PROJECT TITLE: Drainage Plan 1921 Richmond NE H-16 ZONE ATLAS/DRNG. FILE #: H16/D119
 DRB #: 95-298 EPC #: _____ WORK ORDER #: _____
 LEGAL DESCRIPTION: Lot 4-B-1 in Block 1A, Miracerros Addition
 CITY ADDRESS: 1921 Richmond Drive NE
 ENGINEERING FIRM: DVC CONTACT: Debbie Cleft
 ADDRESS: 6212 Terrell NE PHONE: 2496196
Albuquerque, N.M. 87109
 OWNER: Bruce Caird CONTACT: Bruce Caird
 ADDRESS: 2425 San Pedro NE PHONE: 881-9696
 ARCHITECT: _____ CONTACT: _____
 ADDRESS: _____ PHONE: _____
 SURVEYOR: _____ CONTACT: _____
 ADDRESS: _____ PHONE: _____
 CONTRACTOR: _____ CONTACT: _____
 ADDRESS: _____ PHONE: _____

**RE: LOT 4-B-1 (H16-D119) DRAINAGE PLAN SUBMITTAL FOR FINAL PLAT APPROVAL.
ENGINEER'S STAMP DATED 7/2/96.**

RE: *Engineer's Certification for 1921 Richmond Dr. NE (H16/D119) Engineer's Stamp Dated 6/21/98.*

Re: Engineer's Certification for 1921 Richmond Dr. NE
(H16/D119)

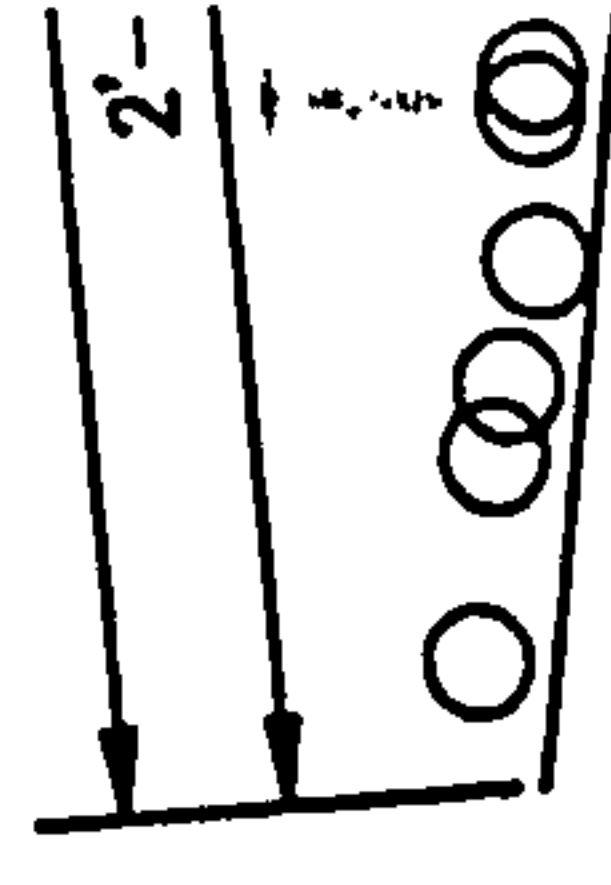
This appears to be
a 20-foot drainage
easement to accept
street water.

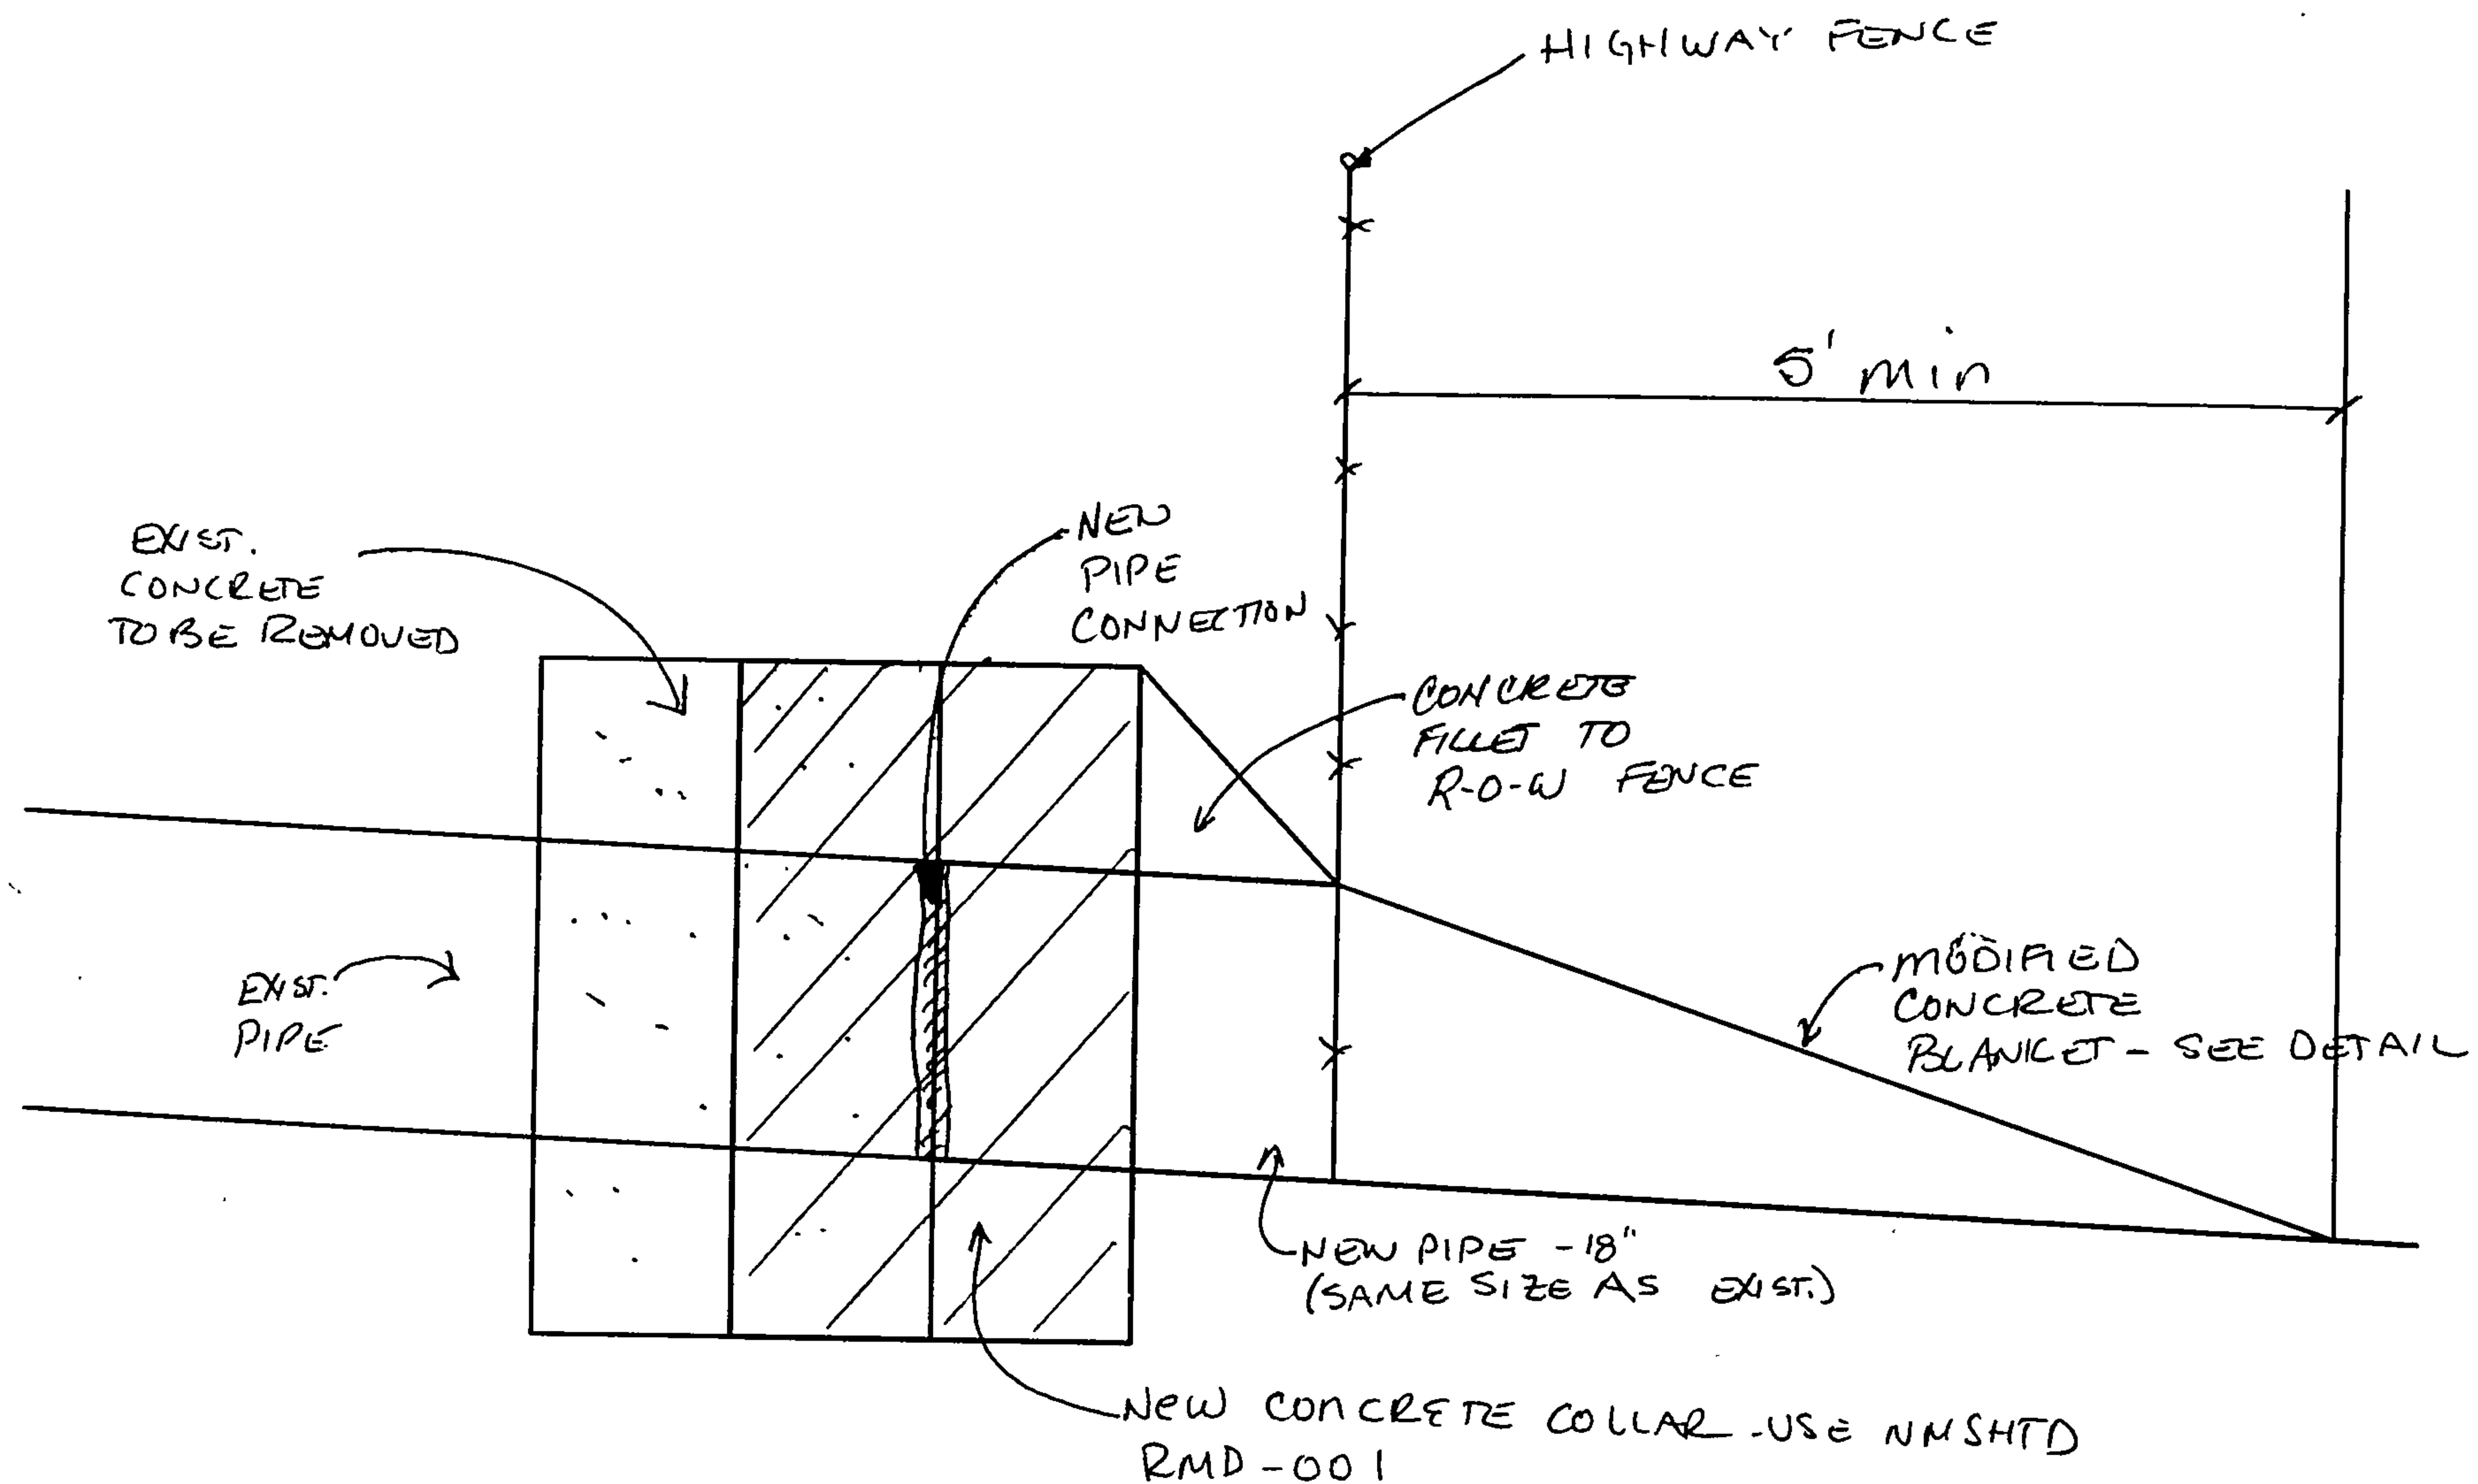
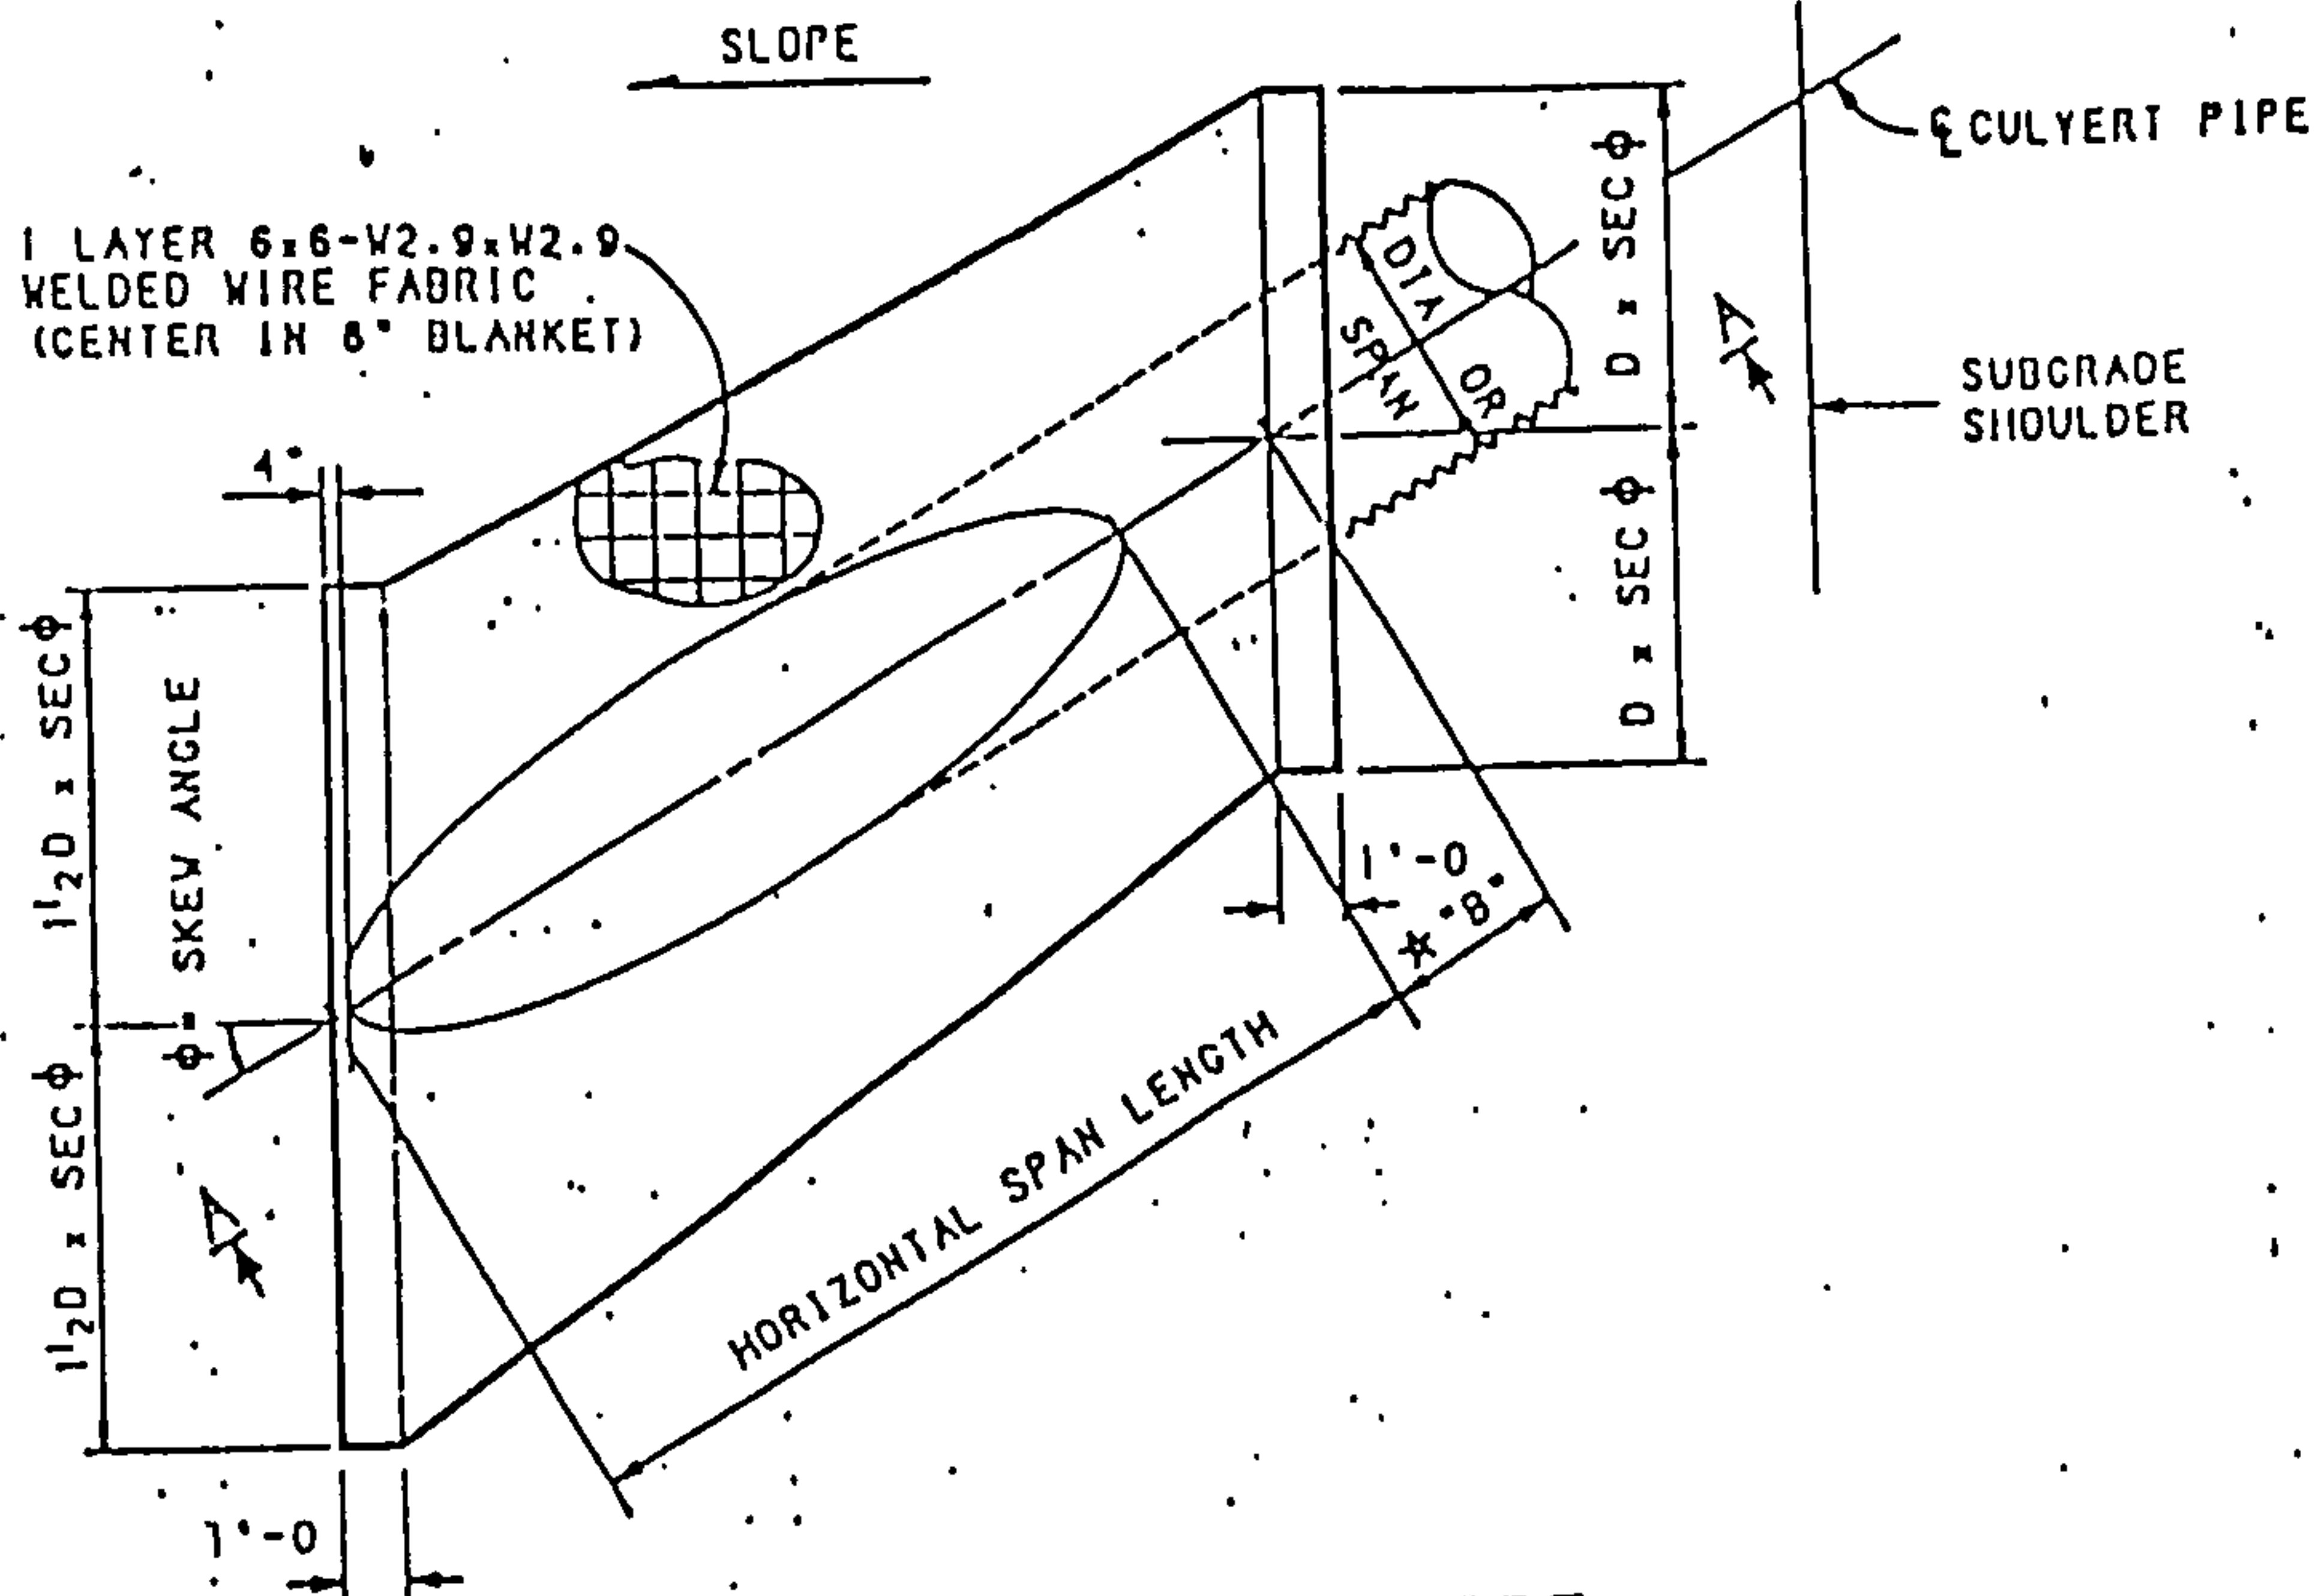
I received your letter and plan details for the 18" culvert extension at Richmond Avenue that drains into the State right-of-way. I concur with the recommendations; and your submittal addressed the May 19, 1998 comments.

However, I recommend to provide an elbow at the pipe extension so as not to direct the flow toward the driving lanes. Please keep the pipe extension as far from the pavement as possible and outside of the clear zone. The clear zone is 33 feet from the edge of the outside driving lane.

The comment was accepted by the property owner and will be constructed detailed with a bend to direct the flow parallel to the driving lanes. A permit has been requested from the District Three Office in Albuquerque to construction within the highway right-of-way and is expected soon.
